Technical Service Bulletin

Subject: WATER ENTRY FROM THE REAR DOOR	Bulletin No.: 09-020/21
	Last Issued : 07/07/2021

2019-2021 Mazda3
2020-2021 CX-30

There are 2 types of new covers: modified service-hole covers and non-modified ones. Images are for the left side door. Mazda3

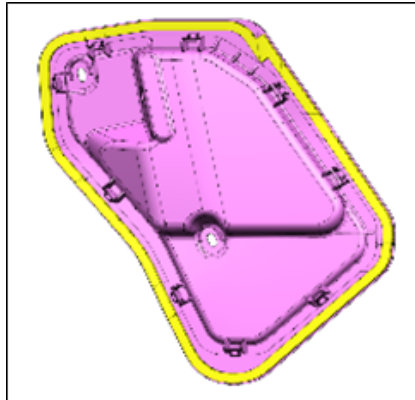
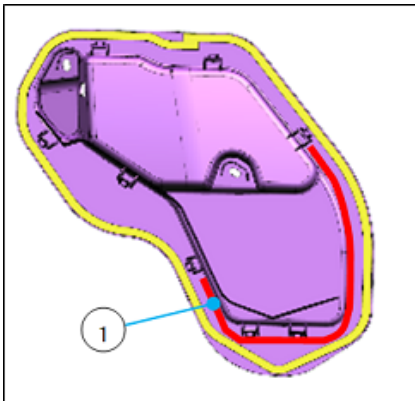
Modified service-hole cover with seal material (1)
B0J8-72-973 / B0J8-73-973

Non-modified service-hole covers
BCJH-72-973E / BCJH-73-973E
BDTS-72-973E / BDTS-73-973E

CX-30

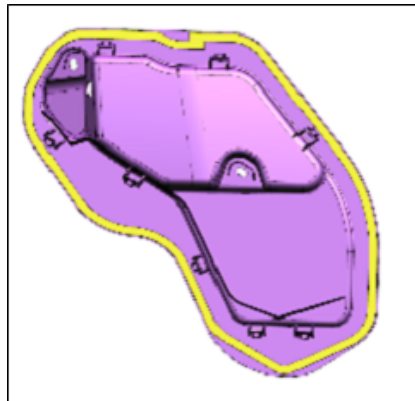
Modified service-hole cover
with a seal material (1)
DFR5-72-973 / DFR5-73-973

Non-modified service-hole cover
DFR5-72-973 / DFR5-73-973
DGH9-72-973 / DGH9-73-973
